SUBJECT: R.E. Ginna Nuclear Power Plant
Docket No. 50-244

Third Supplemental Response to NRC Generic Letter 2004-002, "Potential Impact of Debris Blockage on Emergency Recirculation During Design Basis Accidents at Pressurized-Water Reactors"

REGNPP GL 2004-02 THIRD SUPPLEMENTAL RAI RESPONSE

Figure 3.3 – Distribution of Small and Large Pieces of Debris in Lower Containment

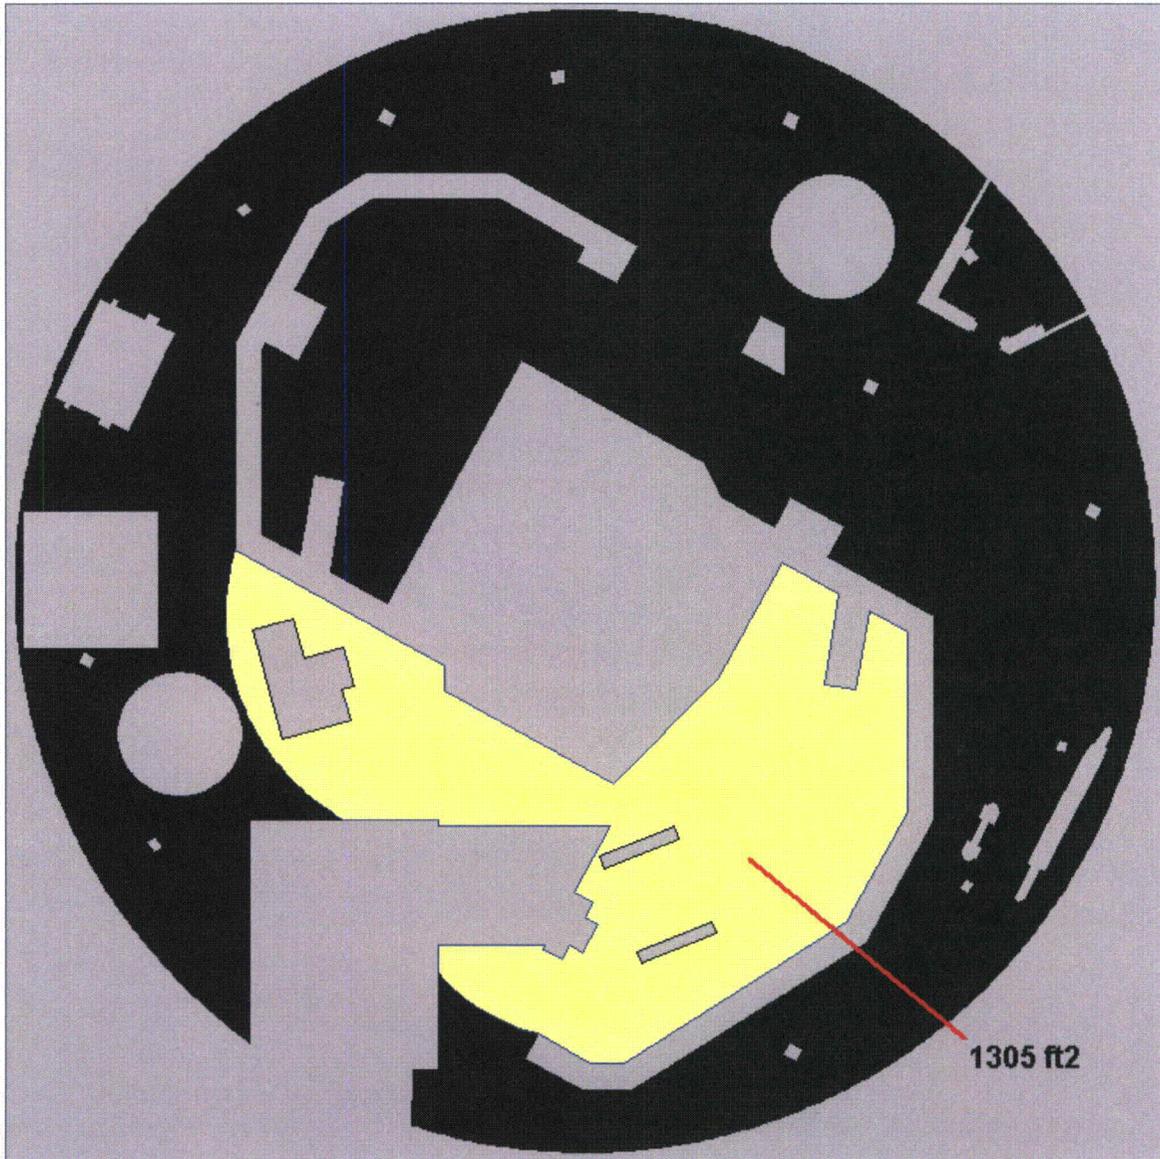
RAI-3: *The supplemental responses did not provide sufficient information for the NRC staff to verify that transport had been adequately evaluated. The licensee should re-submit a transport evaluation in accordance with the revised content guide (ADAMS Accession No. ML073110389). The licensee should refer to previous adequate transport supplemental responses, such as the one provided for Crystal River (ADAMS Accession Number ML080640544). In developing a revised transport response, the licensee should specifically consider the following non-exhaustive list of subject areas:*

The small RMI debris was assumed to be distributed as shown in Figure 3.33.3. This area was overlaid on top of the plot showing tumbling velocity and flow vectors to determine the recirculation transport fraction.

The area where small pieces of RMI would transport within the initial distribution area is 506 ft² as shown in Figure 3.43.4. Since the initial distribution area was determined to be 1,305 ft², the recirculation transport fraction for small pieces of RMI is 39%.

Figure 3.7 – Temp-Mat Small Pieces Debris Transport Logic Tree (Case 1)

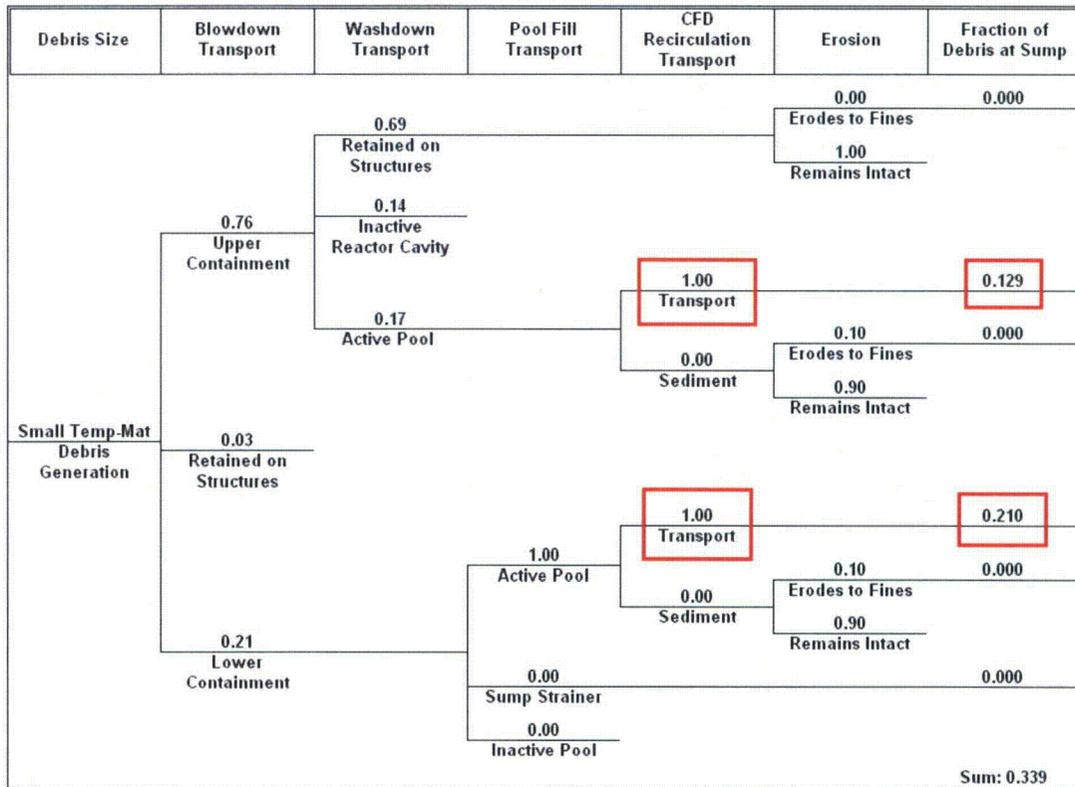
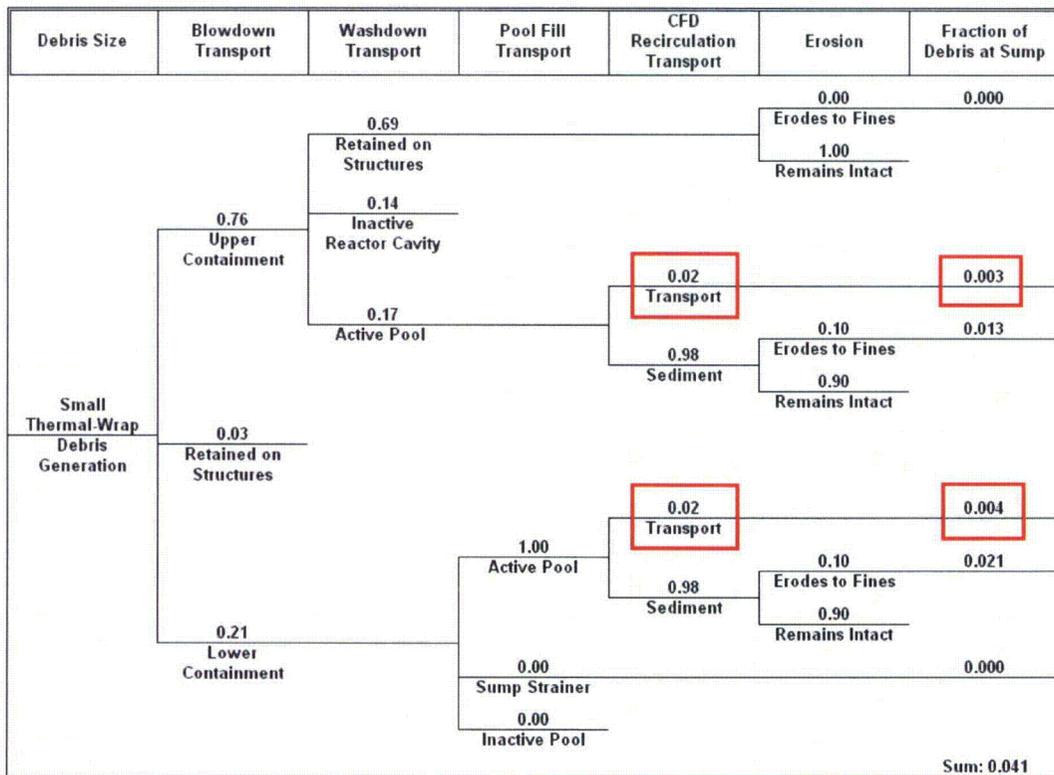
- j) *A discussion as to why the transport fractions for Temp-Mat are higher than for Thermal Wrap. Presumably, the denser fiberglass (Temp-Mat) would be less transportable for equivalent sizes of debris than the less dense fiberglass (Thermal Wrap). However, the results presented in the supplemental response show the opposite behavior.*

Within the small and large piece Thermal-Wrap logic trees, the calculated recirculation transport fractions were used. However, for Temp-Mat small and large pieces, the logic trees conservatively assumed that all small and large pieces of Temp-Mat in the containment pool transport to the sump (a recirculation transport fraction of 100%). Using two example logic trees from a single case and debris size (Figure 3.73.7 and Figure 3.8), it can be seen that using the actual transport fraction for Thermal-Wrap and an overly-conservative 100% transport fraction for Temp-Mat accounts for this difference.

Figure 4.1: Ginna Strainer Testing – Fiber Fines Debris Addition to the Test Loop

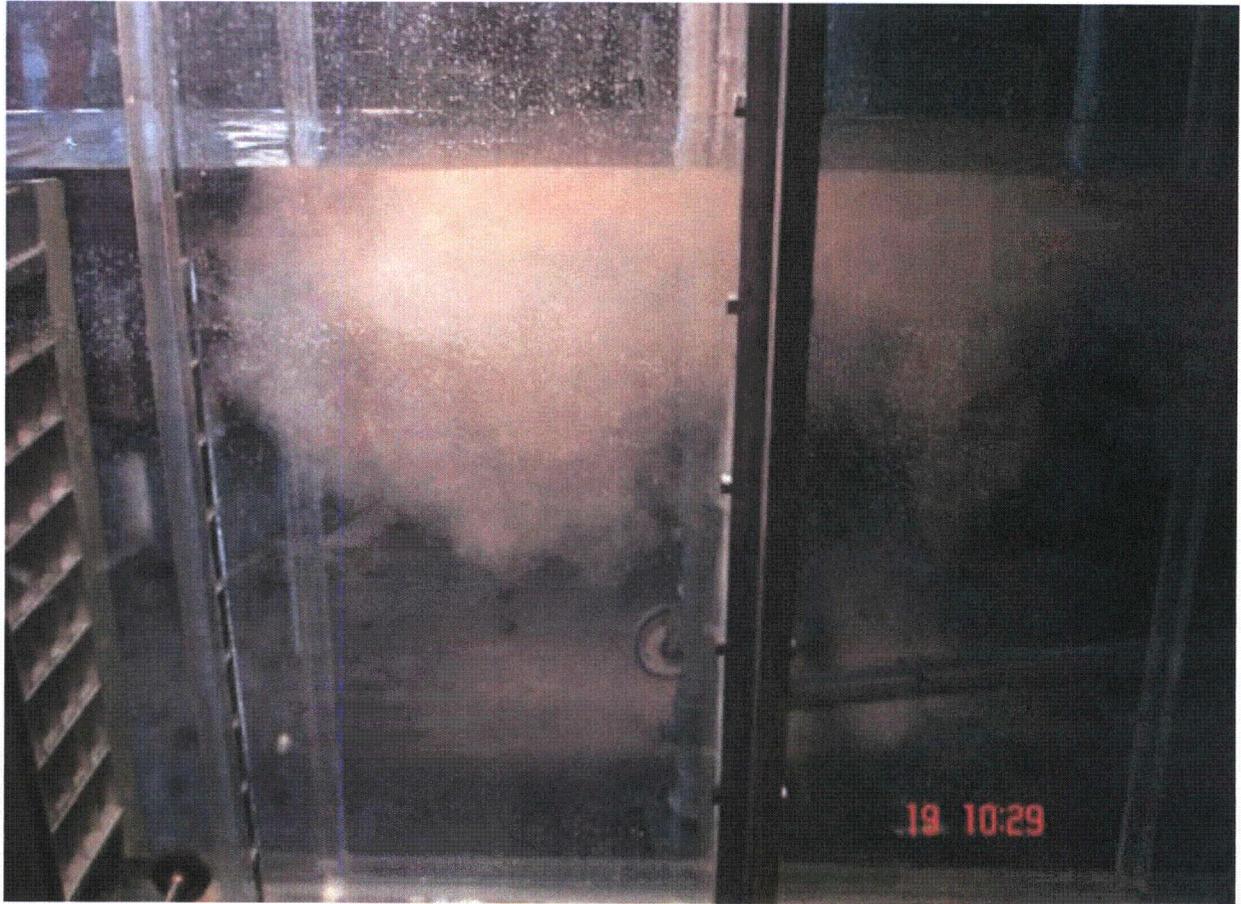
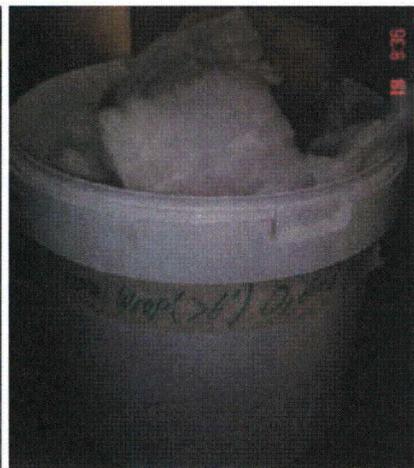
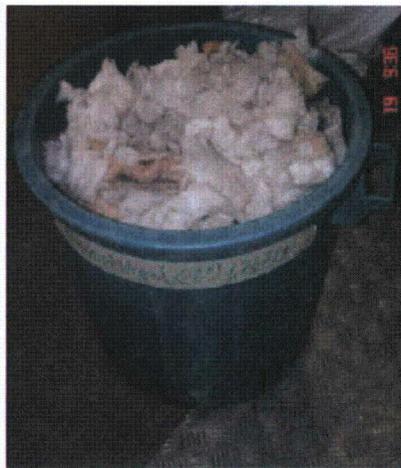
RAI-4: *Please provide verification that the fibrous size distribution used during testing was prototypical or conservative compared to the size distribution predicted by the transport evaluation.*

Small fiber pieces (<6”) were prepared by chopping the specified quantity of fibrous insulation in approximately 1” x 1” squares and shredding the pieces. Large and intact fiber insulation (>6”) were conservatively combined as a single debris size class. The specified quantities were prepared by chopping the insulation in approximately 6” x 6” squares. Water was added to the barrels of fibrous debris several hours before addition to the test loop to allow sufficient soaking time for the fiber. Photos of the prepared fibrous debris follow (Figure 4.2).

Figure 5.1: CCI Multi-functional Test Loop

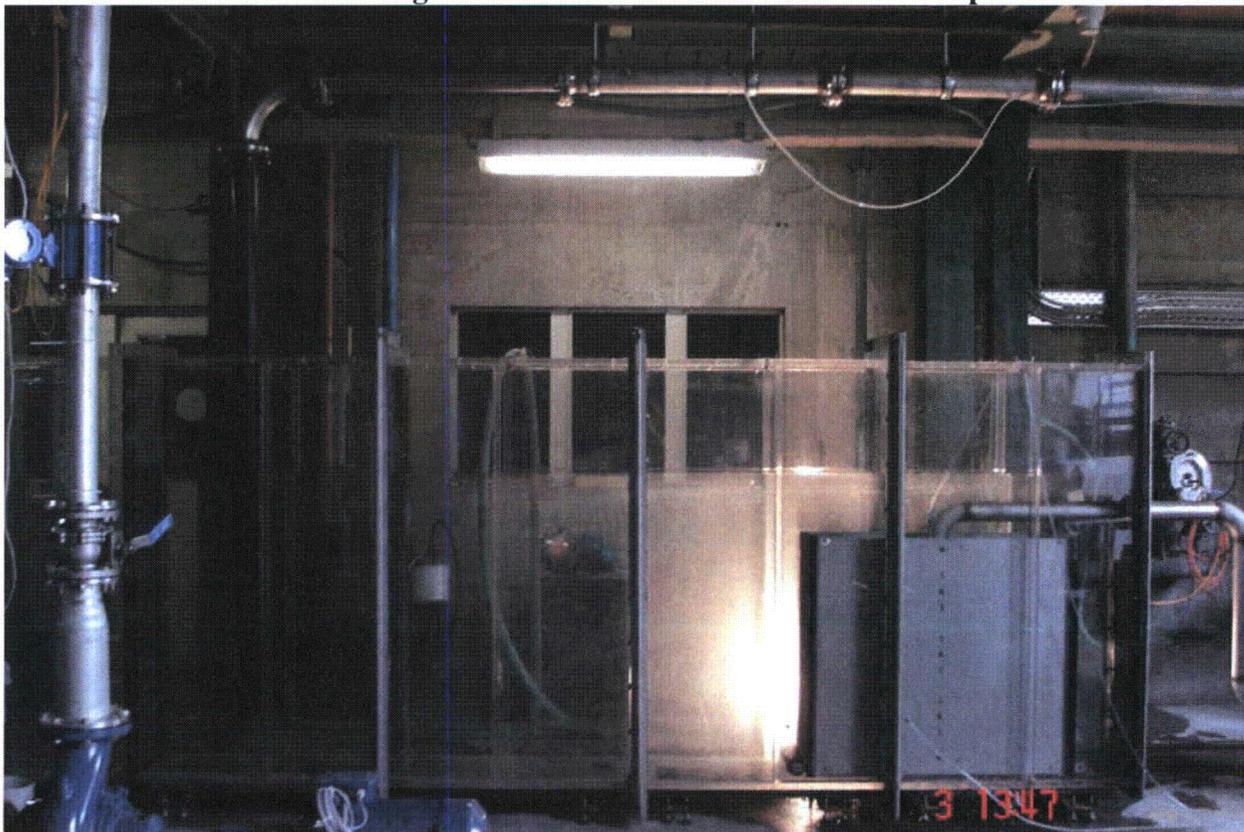
RAI-5: *Please provide details of the debris addition procedures used. Please include a description of fibrous concentration during debris addition, the debris addition location, and the method of adding fibrous debris to the test tank. Please provide verification that the debris introduction processes did not result in non-prototypical settling, agglomeration, or deposition of debris.*

RAI-5 Response: The test loop in which strainer head loss testing was conducted consists of a tank approximately 12 m long x 0.5 m wide x 2 m high. A double sided strainer segment is positioned at one end of the test tank. Pump suction is taken from the center channel of the strainer and circulated to the opposite end of the test tank, through a submerged sparger. Test debris is added to the test tank near the surface of the tank water above the sparger location (Figure 5.1).

Figure 8.1: Ginna Strainer Head Loss Test 1 Results

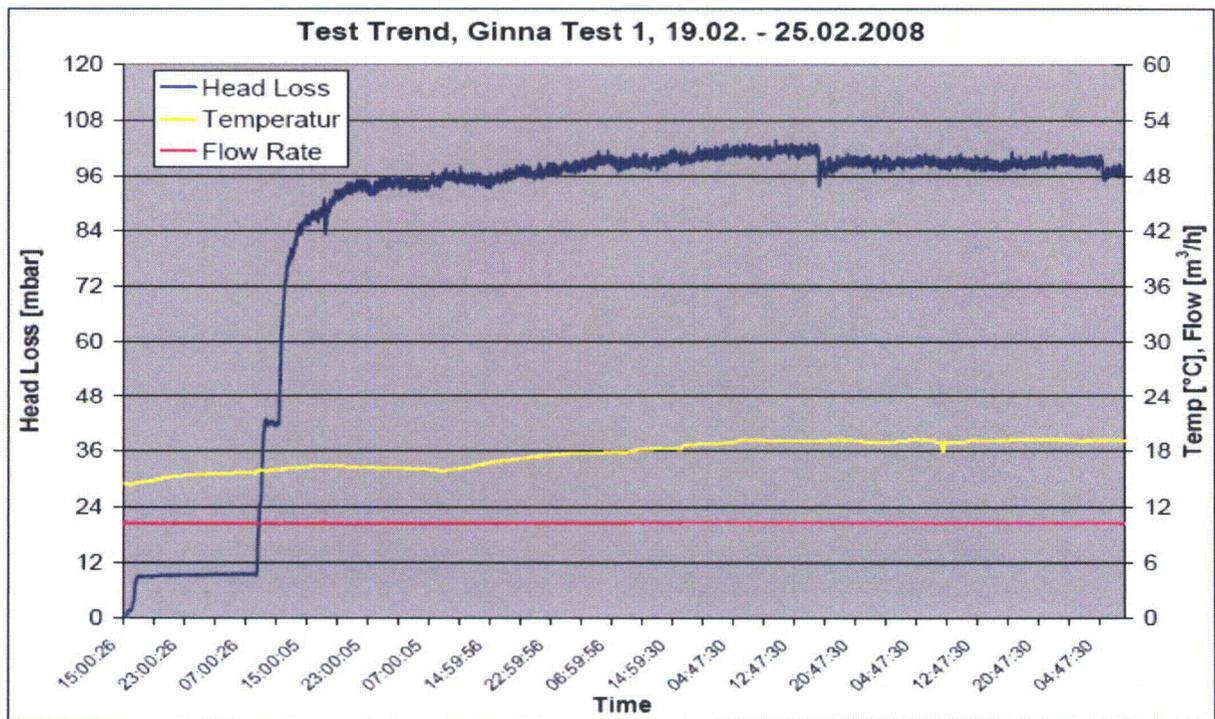
RAI-8: *Please provide the test termination criteria and the methodology by which the final head loss values were extrapolated to the ECCS mission time or some predicted steady state value. Please include enough test data to allow the extrapolation results to be verified.*

During strainer head loss testing, head loss values were taken every 30 seconds. As can be seen in the Test 1 plot of strainer head loss values (Figure 8.1), the head loss was stable for nearly 2 days prior to the termination of the test. The head loss during this time had minimal variation (+/- 2 mbar) and the overall trend was steady, to trending down. As a result, it was determined that the maximum strainer head loss had been achieved and no extrapolation of head loss data was performed. The maximum head loss achieved during the test, adjusted for test tank fluid temperature variations and normalized to 20 °C, was 95.2 mbar [8.4]. Since this head loss was the maximum achieved and since subsequent head loss measurements were lower and stable, to trending down, 95.2 mbar at 20 °C was taken as the maximum sump strainer head loss due to debris on the strainer. This value is equivalent to 29.7 mbar (0.99 ft WC) corrected to the minimum containment recirculation pool design temperature of 195 °F.

Figure 12.1: Ginna Strainer Head Loss Test 1 Results

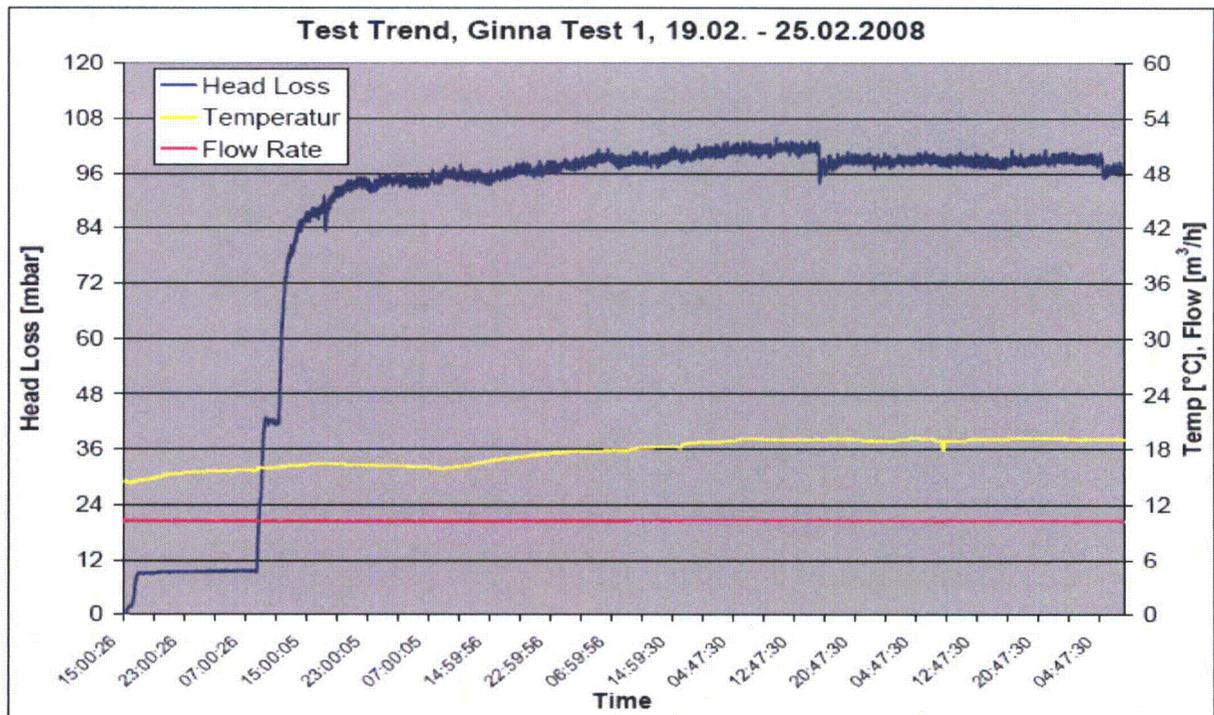
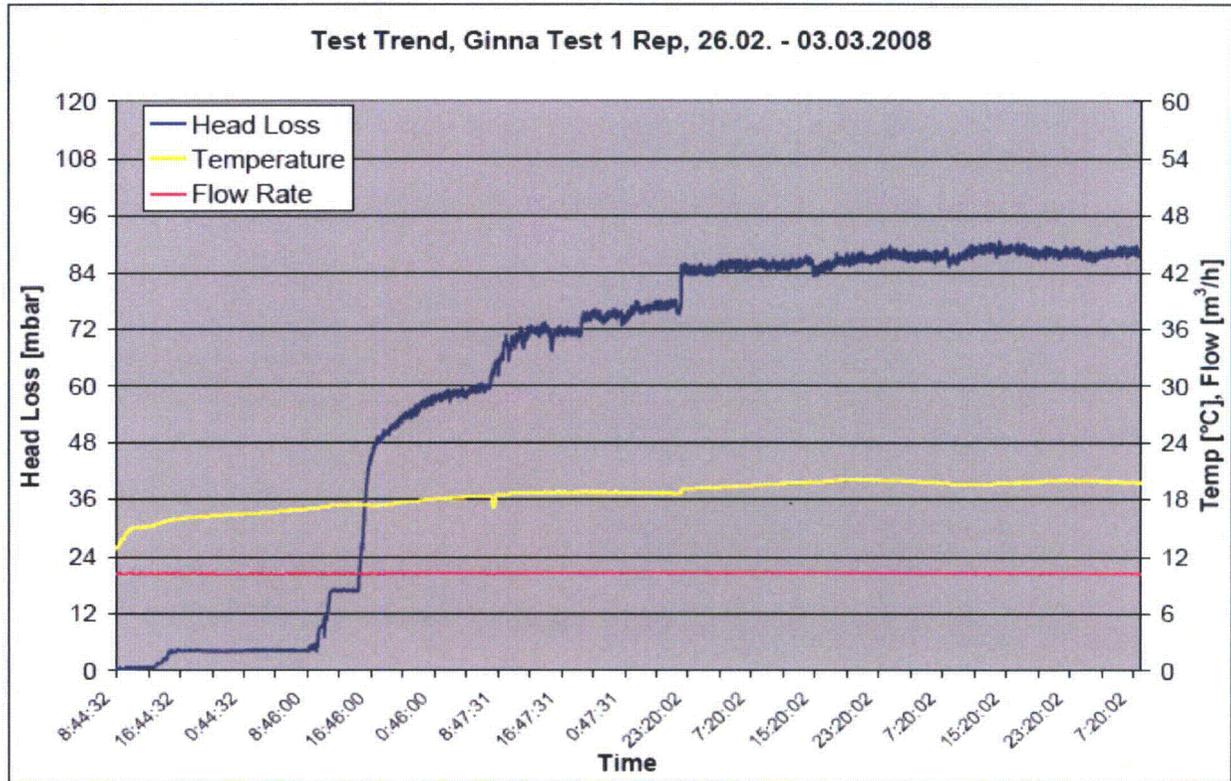
RAI-12: Please provide information that shows that pressure-related phenomena (e.g., boreholes or channeling) did not occur during testing. A description of flow sweeps conducted following testing that shows a head loss change is approximately proportional to flow change is acceptable for this purpose.

RAI-12 Response: The results of the Ginna head loss testing with full debris load, including chemical precipitants, (Figure 12.1 and 12.2) showed no evidence of bore holes or channeling. The strainer head loss over the 4 days of testing, following the introduction of debris, showed minimal variation of head loss and no open strainer surface area. The variation of head loss, from peak to trough, was approximately 6 mbar, with no sudden change of head loss that could be attributed to any pressure related phenomena. This conclusion was further supported by direct observation of the debris bed (Figure 12.3). Two separate tests were conducted with very similar results. Had any pressure related phenomena existed, the results of these tests would not have so closely resembled each other. The strainer head loss, for which temperature/viscosity correction was applied, was taken as the most conservative value for the head loss and test pool water temperature.

Figure 15.1: Ginna Strainer Head Loss Test 1 Results

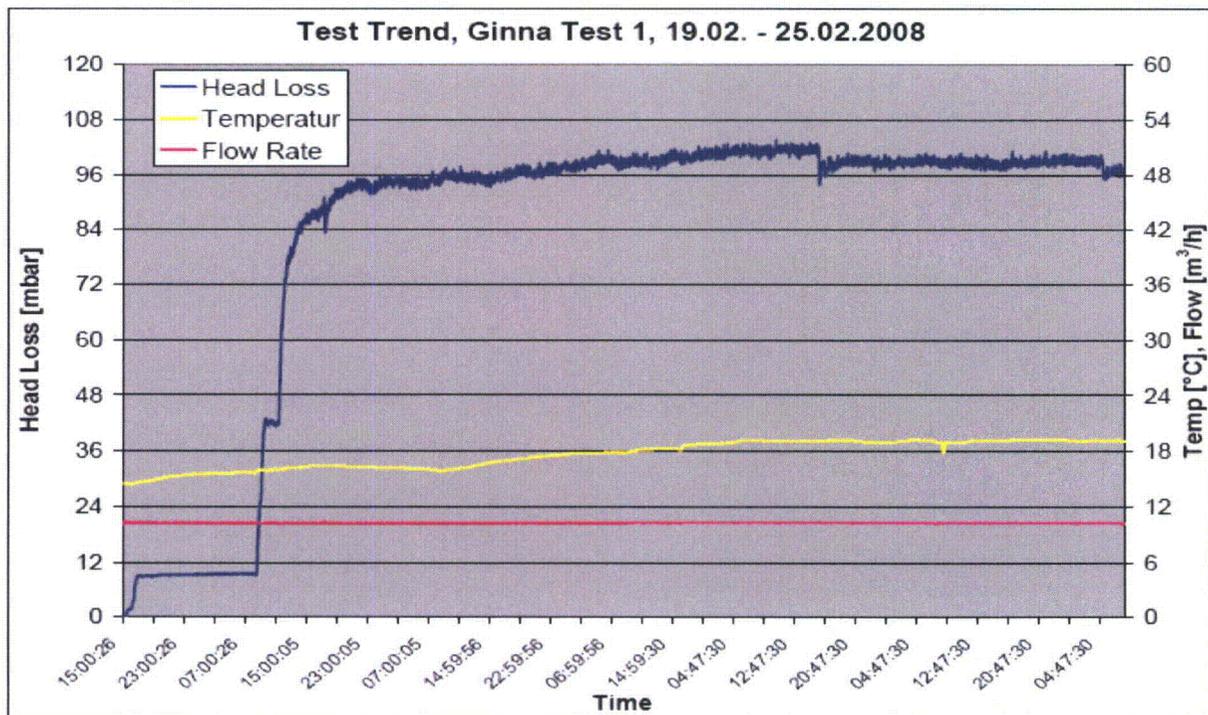
RAI-15: *Please provide the following information as discussed in Enclosure 3 to a letter from the NRC to NEI dated March 28, 2008 (ADAMS Accession No. ML080380214). Specifically, please provide the information requested by item 16.d on page 20 (termination criteria) and items 17.d.i and 17.d.ii on page 21 (test pressure drop curve and an explanation of any extrapolation of data).*

During strainer head loss testing, head loss values were taken every 30 seconds. As can be seen in the Test 1 plot of strainer head loss values (Figure 15.1), the head loss was stable for nearly 2 days prior to the termination of the test. The head loss during this time had minimal variation (± 2 mbar) and the overall trend was steady, to trending down. As a result, it was determined that the maximum strainer head loss had been achieved and no extrapolation of head loss data was performed. The maximum head loss achieved during the test, adjusted for test tank fluid temperature variations and normalized to 20 °C, was 95.2 mbar [15.4]. Since this head loss was the maximum achieved and since subsequent head loss measurements were lower and stable, to trending down, 95.2 mbar at 20 °C was taken as the maximum sump strainer head loss due to debris on the strainer. This value is equivalent to 29.7 mbar (0.99 ft WC) corrected to the minimum containment recirculation pool design temperature of 195 °F.
